Service Bulletin No. 430

MODEL J4500 Series	TYPE Field Change Program	SECTION/GROUP 3-Body	DATE Jan. 11, 2016
SUBJECT KIEL PASSENGER SEAT			
CONDITIONS

Ref. MCI NHTSA Recall No.:15V-862

Figure 2. Correct installation of mounting hardware.

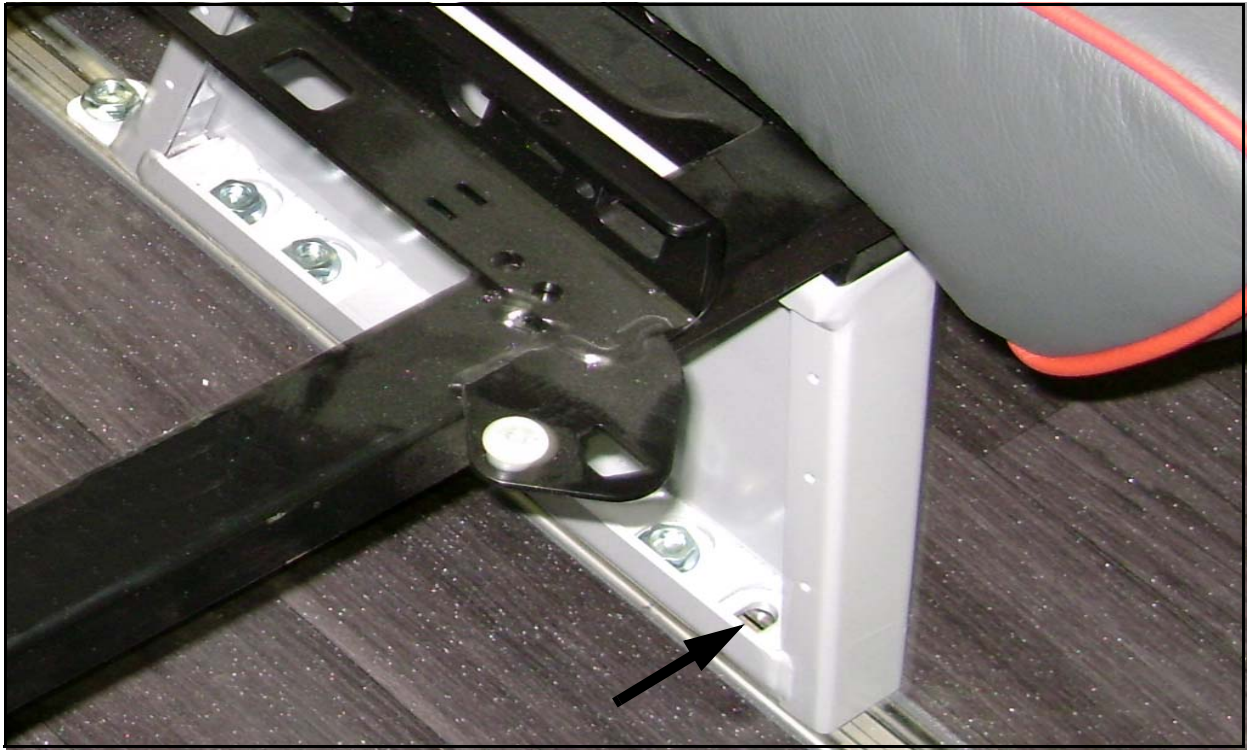
If the mounting hardware is installed correctly as shown in Figure 2, no further action required. Re-install the cover panel to the seat base using the two (2) snap fasteners, p/n 19-05-0304.

Figure 3. Incorrect installation of mounting hardware.

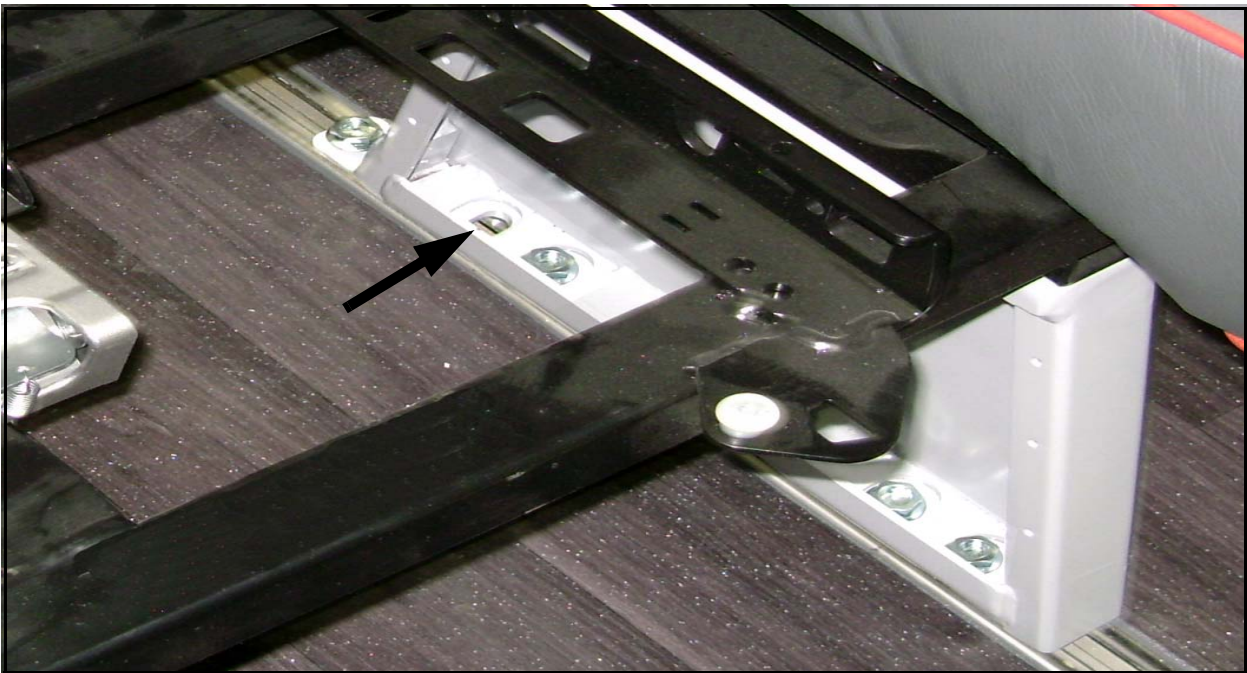
If the mounting hardware is installed incorrectly as shown in Figure 3, proceed to Step 7.

Figure 4. Floor track t-bolt locked angle.

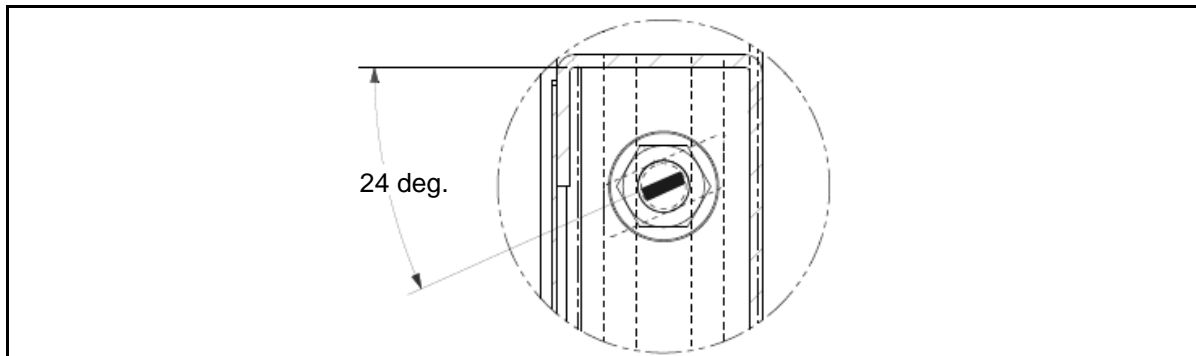
For proper installation, do not install a t-bolt at the location marked with an X in Figure 5.

13. Orient and align the four (4) new t-bolts, p/n 3R-11-32, in the floor track. Slide under the seat pedestal until the t-bolt is aligned with the seat pedestal hole at the four (4) locations shown in Figure 5. Rotate the t-bolt to lock into the floor track. The notch on top of the t-bolt should be at 24 degrees when locked in place (refer to Figure 4).

Figure 6. Sidewall track t-bolt locked angle.

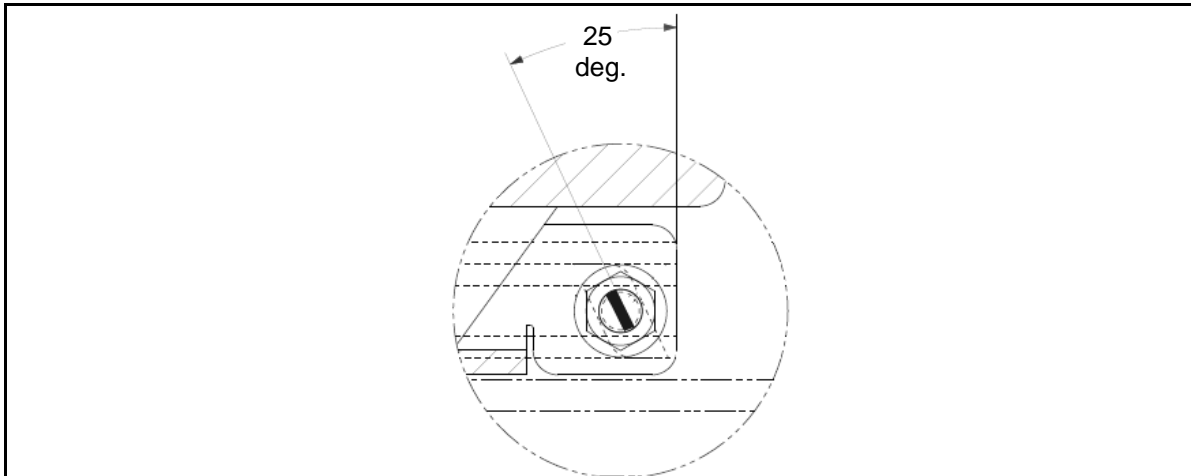
14. Orient and align three (3) new t-bolts, p/n 3R-11-24, with the marks made on the sidewall track. Rotate the t-bolt to lock into the sidewall track. The notch on top of the t-bolt should be at 25 degrees when locked in place as shown in Figure 6.

Figure 7. Coach sidewall t-bolt location.

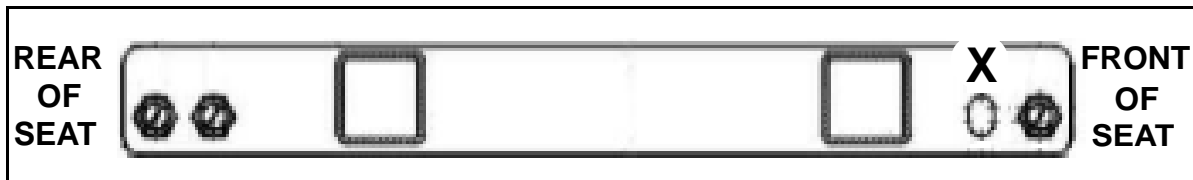
For proper installation, do not install a t-bolt at the location marked with an X in Figure 7.
